ADDENDUM NO. 1

Date: August 11, 2023
Project Name: Runway 18L-36R Pavement Reconstruction
Owner: Denton Enterprise Airport
TxDOT CSJ No.: 2318DENTN
Garver Project No. 23A11280

DRAWING NUMBER
EL-104

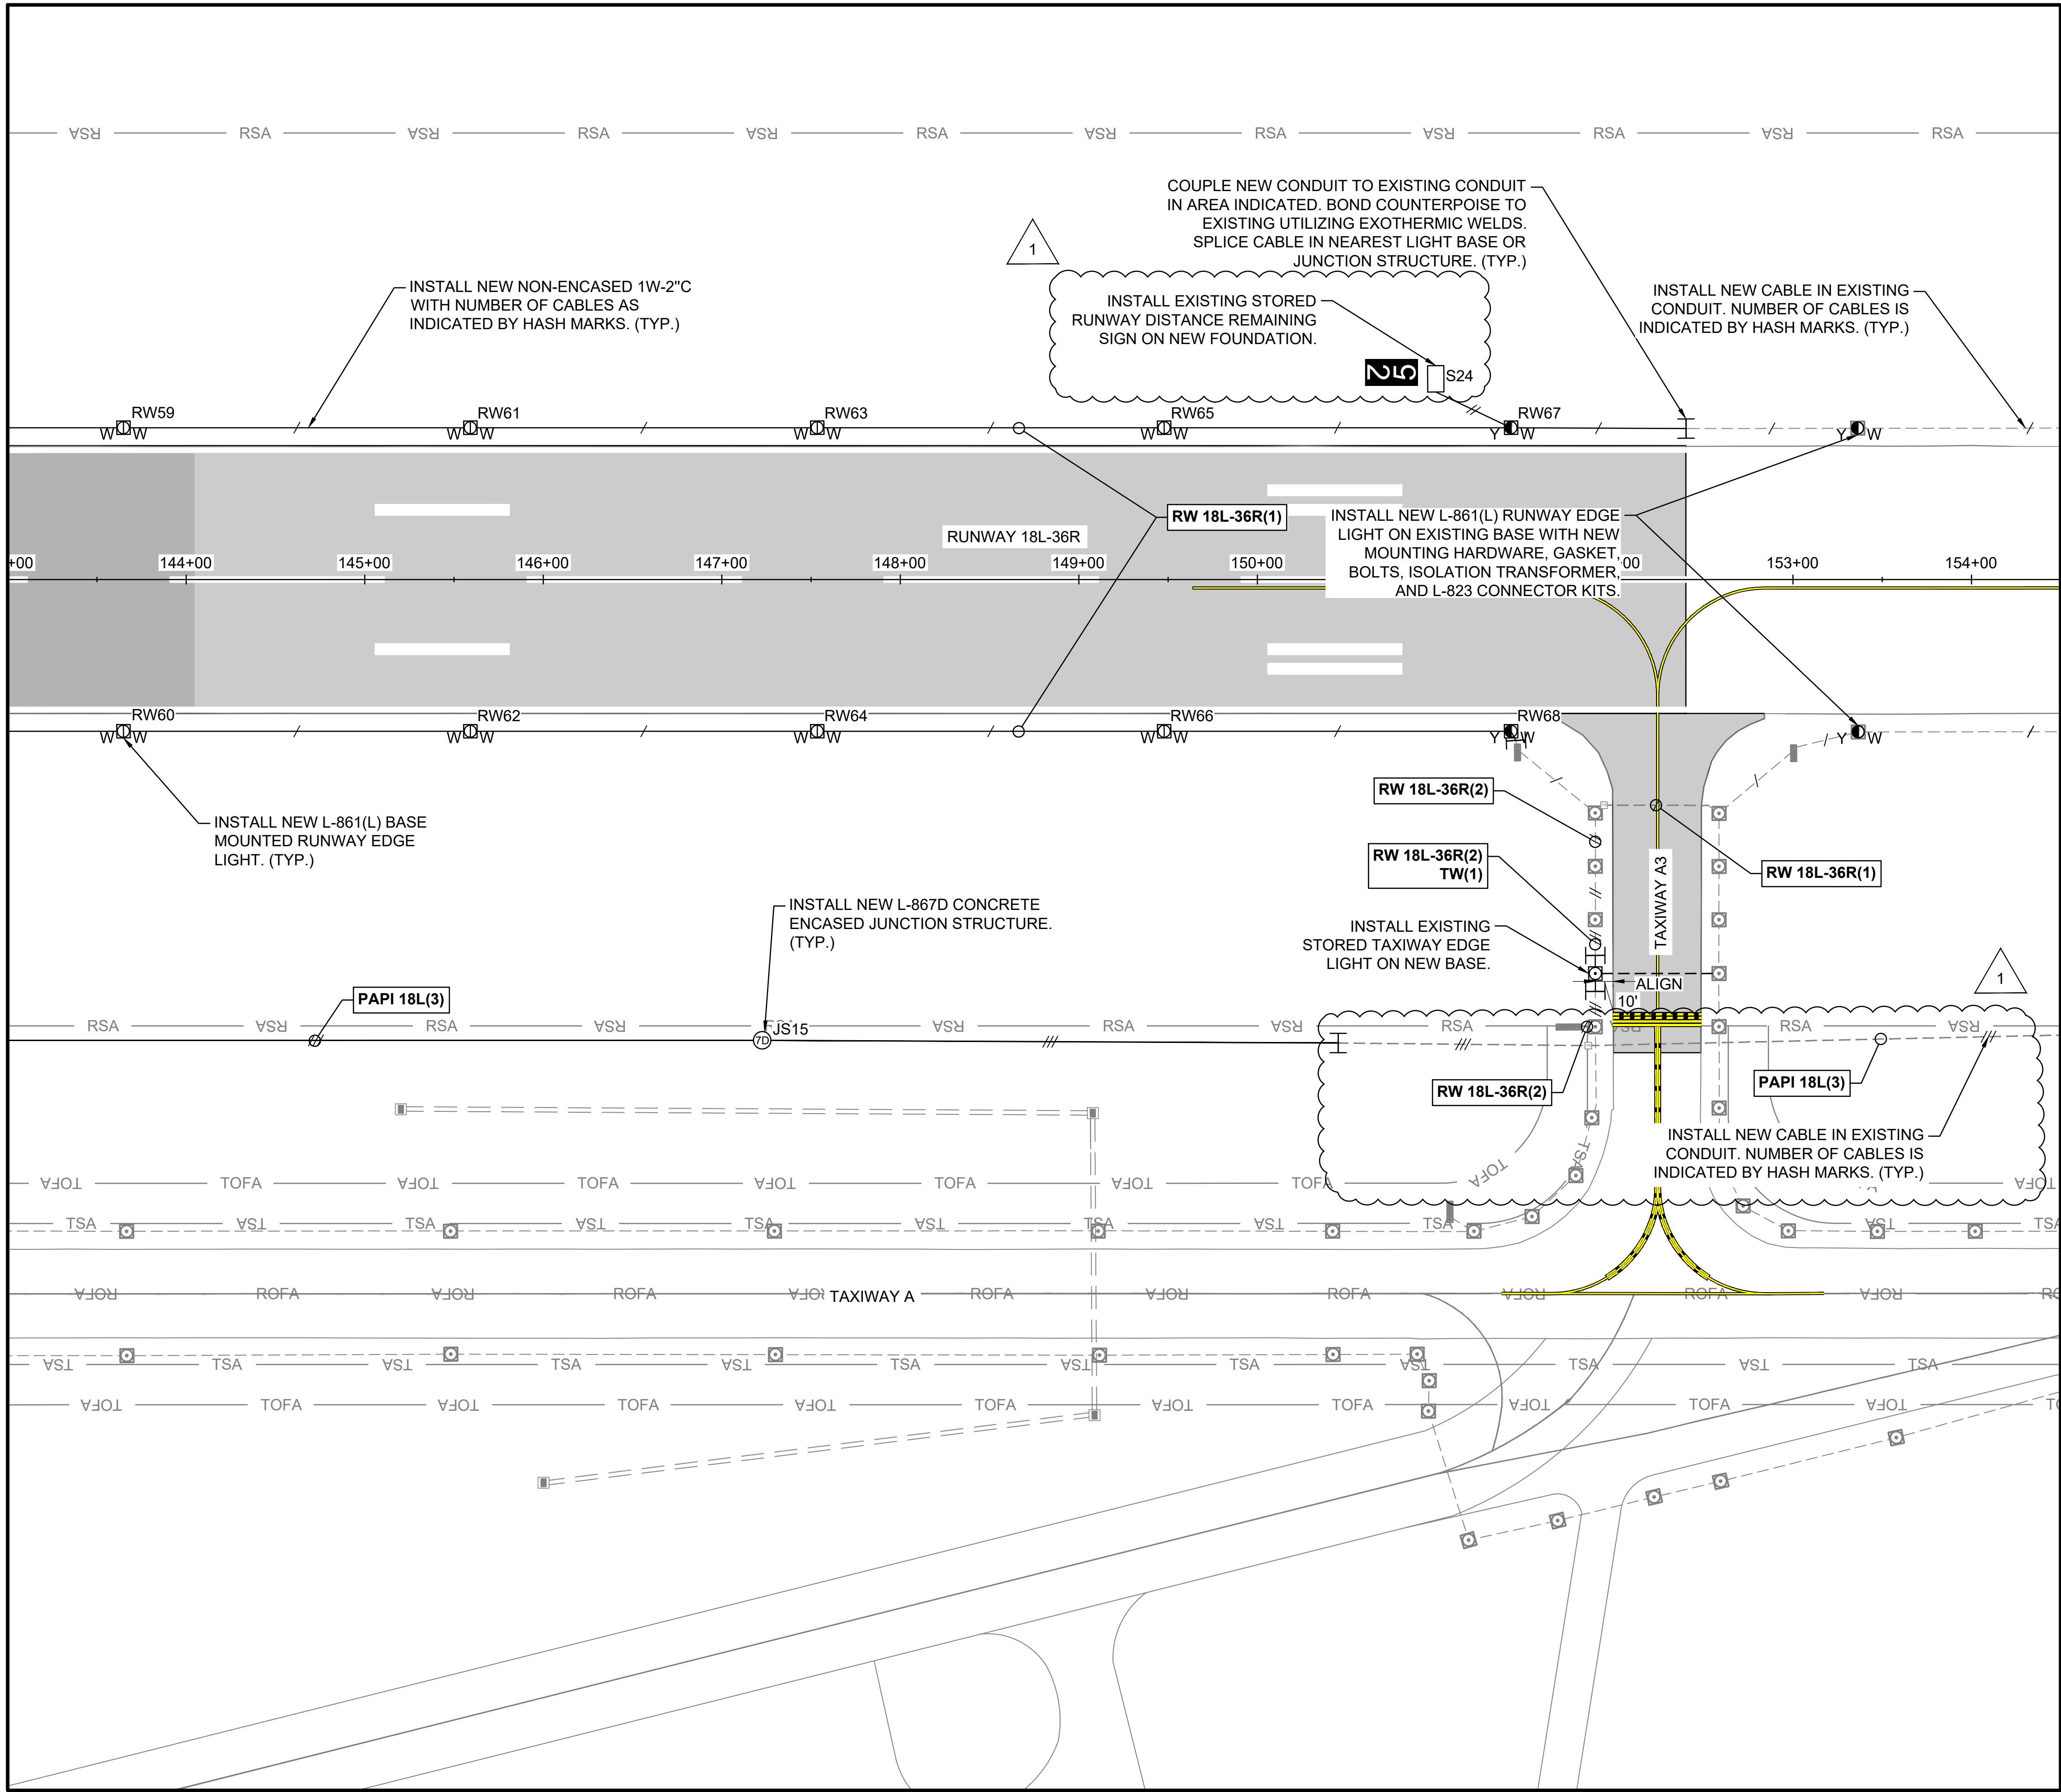
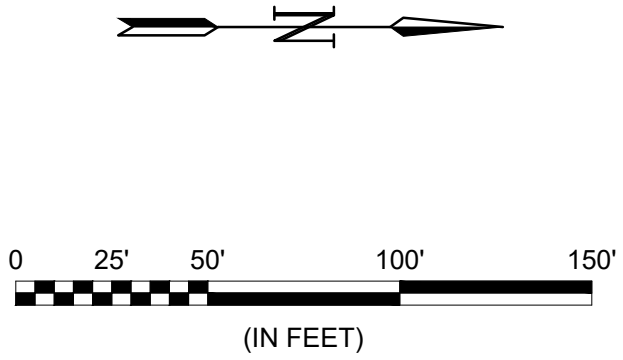
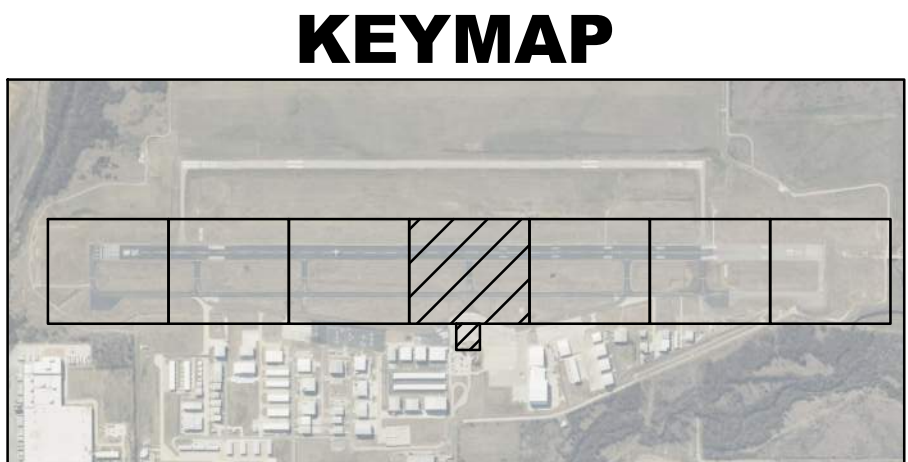
15. Updated Lighting Installation Plan 4, updated to include PAPI replacement. Sheet "EL-104 Lighting Installation Plan 4"
16. Updated Lighting Installation Plan 5, updated to include PAPI replacement. Sheet "EL-105 Lighting Installation Plan 5"

4
EL-204
EXISTING STORED RDR SIGN
SCALE: NONE

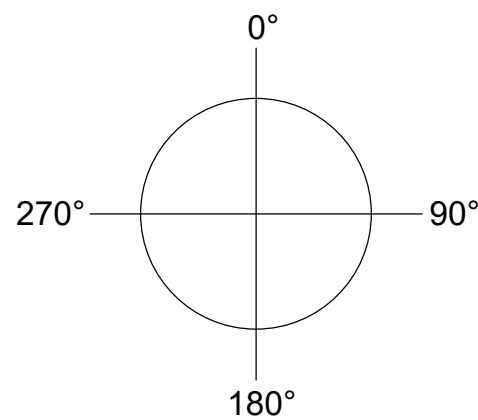
17. Updated Lighting Installation Plan 6, updated to include PAPI replacement. Sheet "EL-106 Lighting Installation Plan 6"
18. Updated Lighting Installation Details 4, Sheet "EL-204 Lighting Installation Details 4"

EL-207B

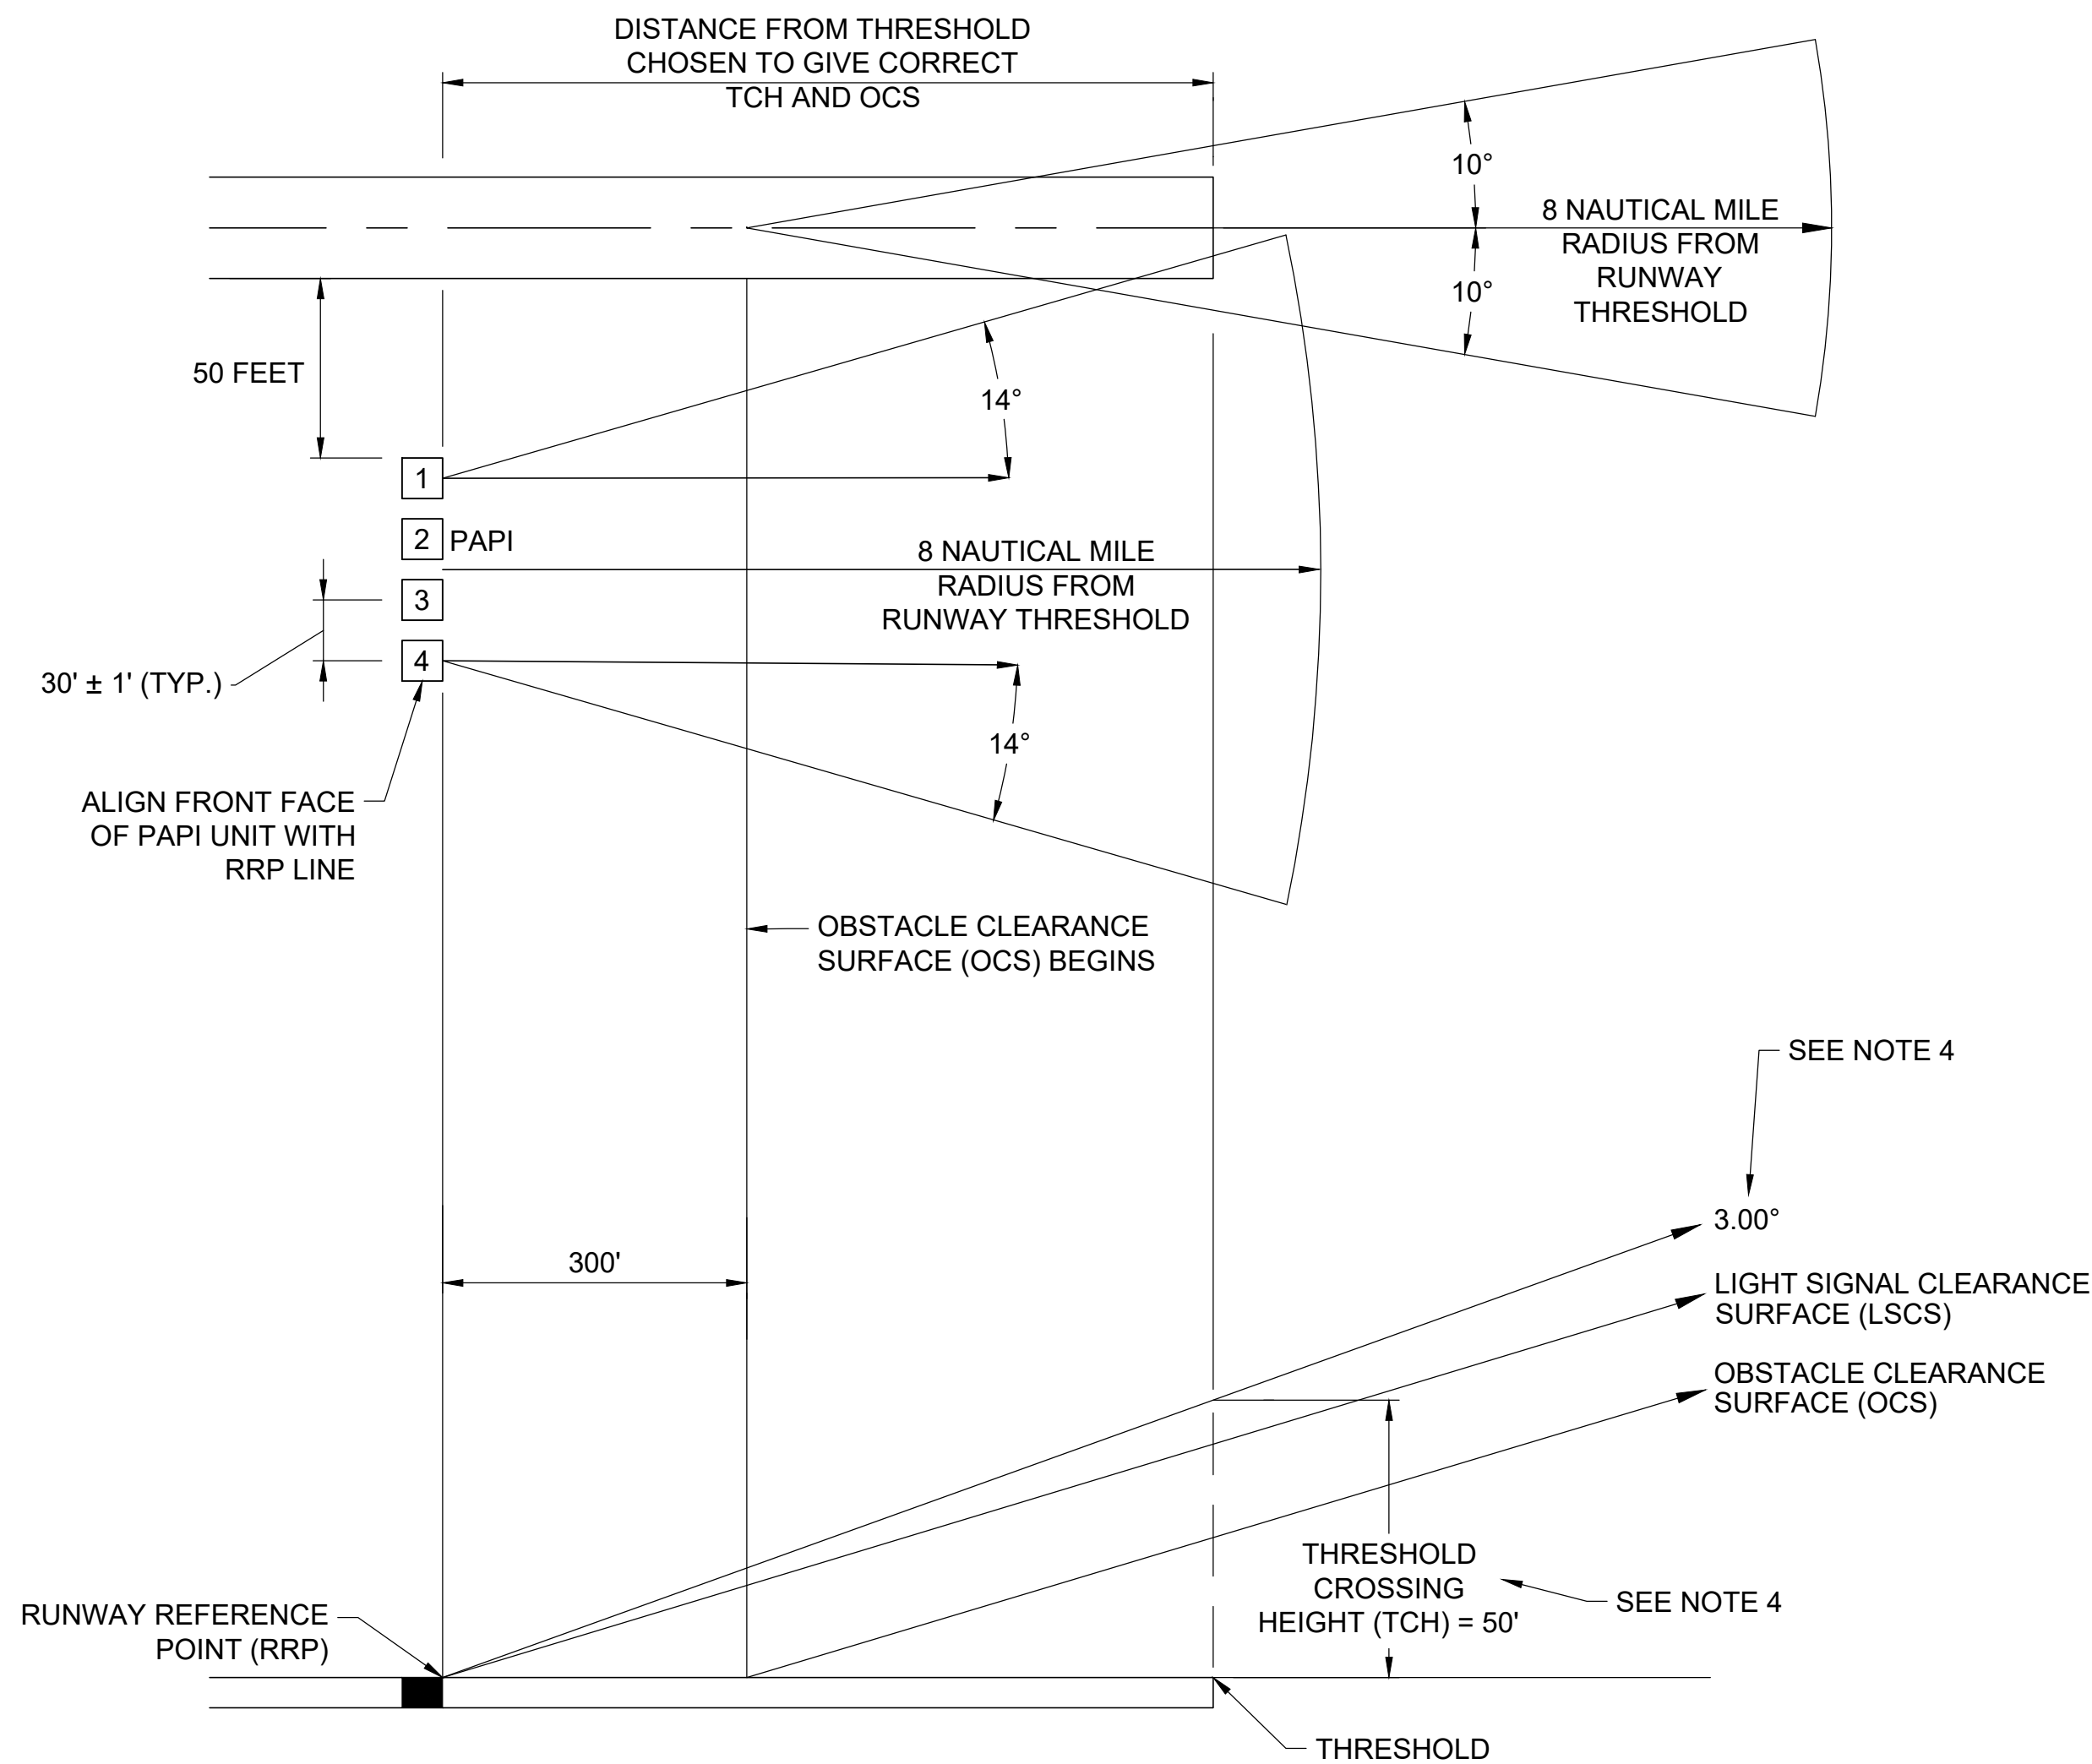
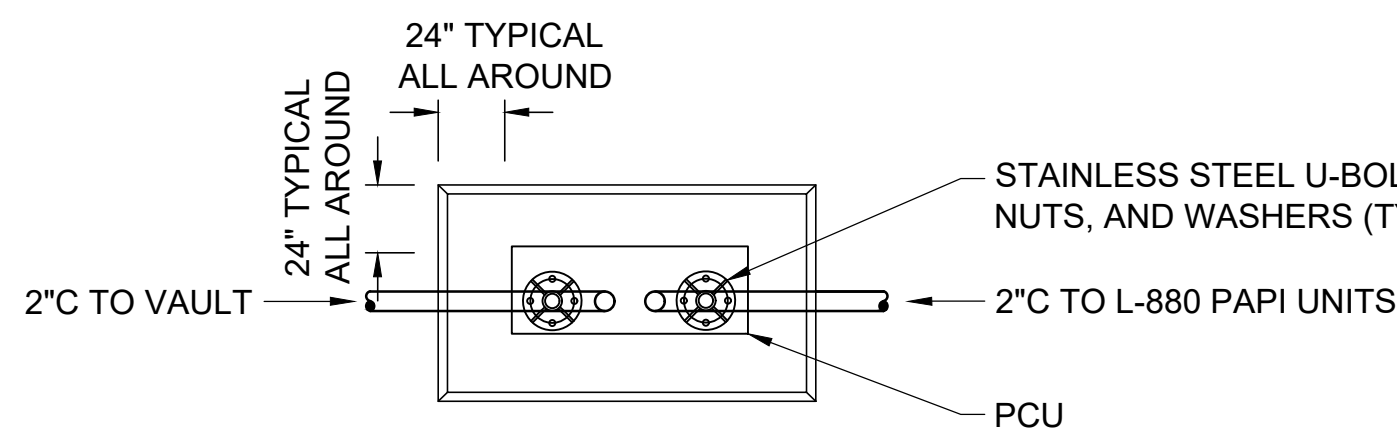
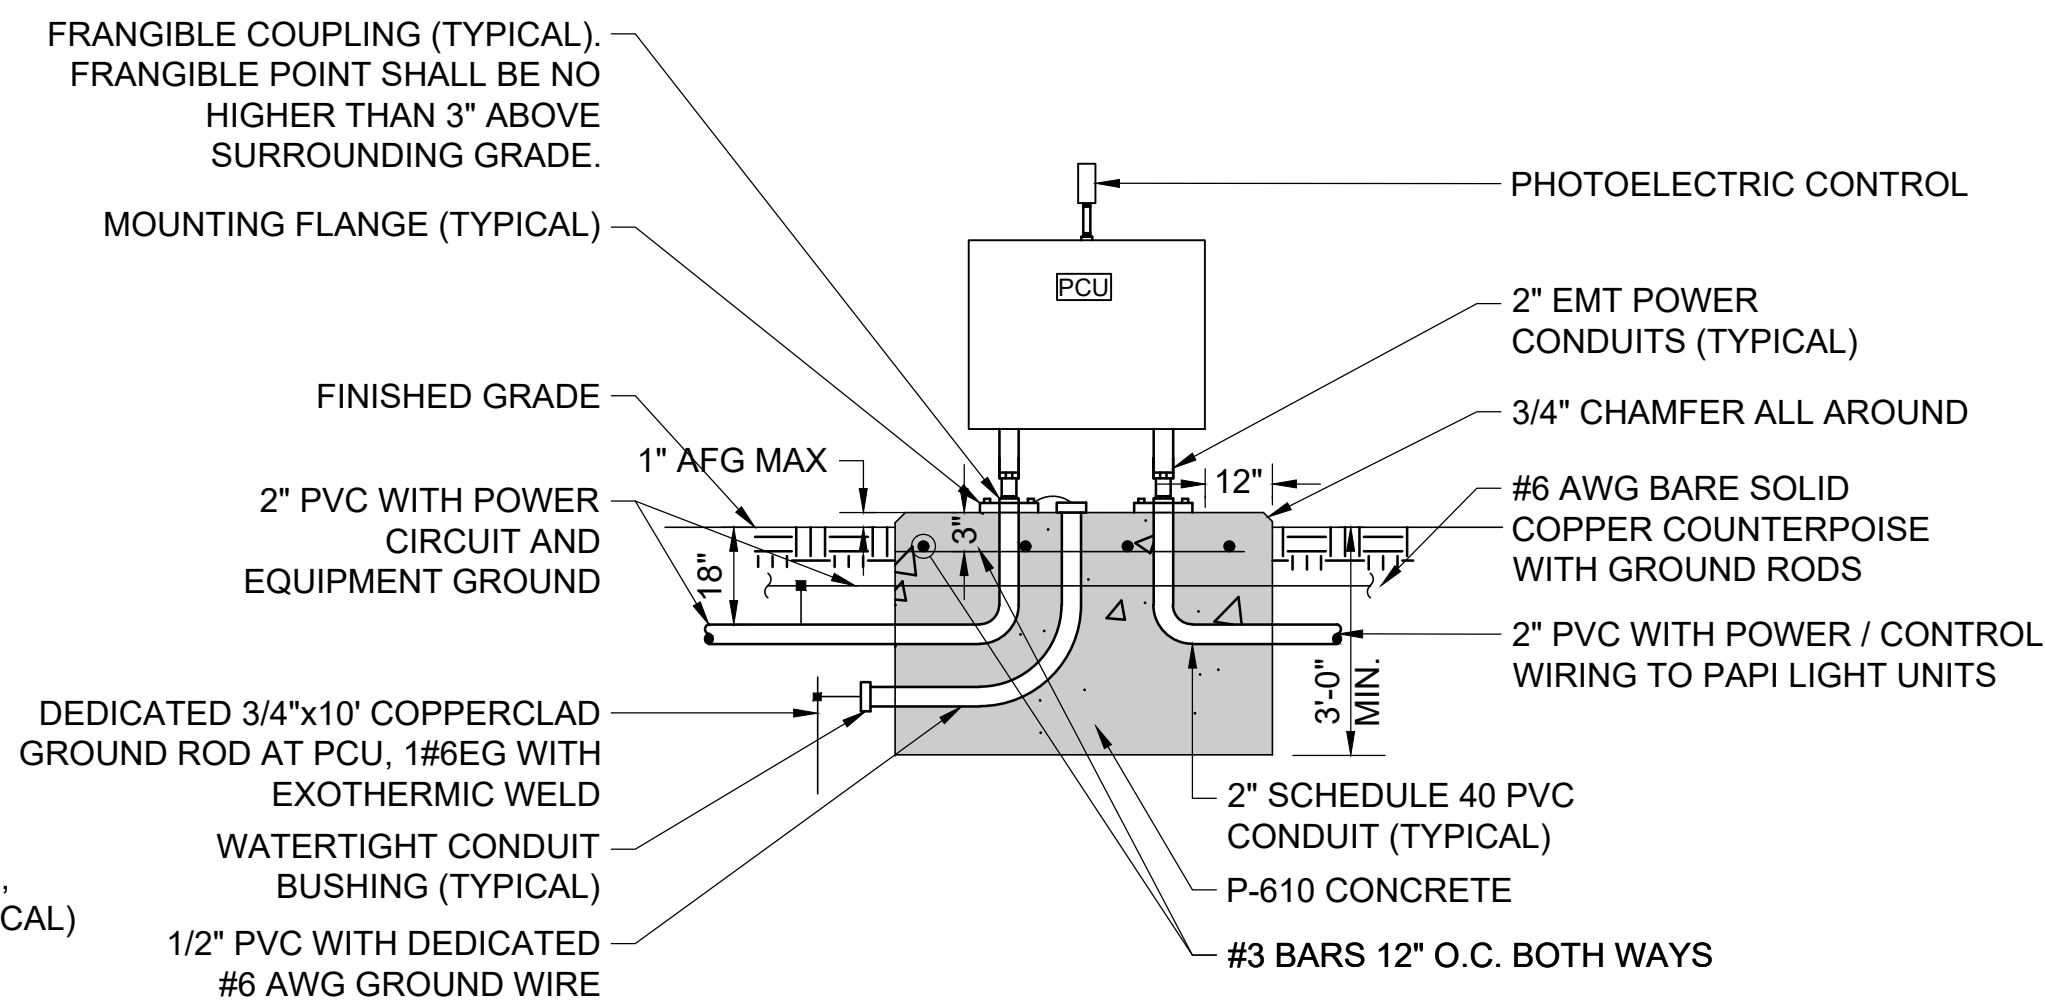
21. Addition of Lighting Installation Details 7B, Sheet "EL-207B Lighting Installation Details 7B"
22. Addition of Lighting Installation Details 7C, Sheet "EL-207C Lighting Installation Details 7C"
23. Updated Lighting Installation Details 9, Sheet "EL-209 Lighting Installation Details 9"
24. Updated Runway Cross Sections 3, Sheet "XS-103 Runway Cross Sections 3"
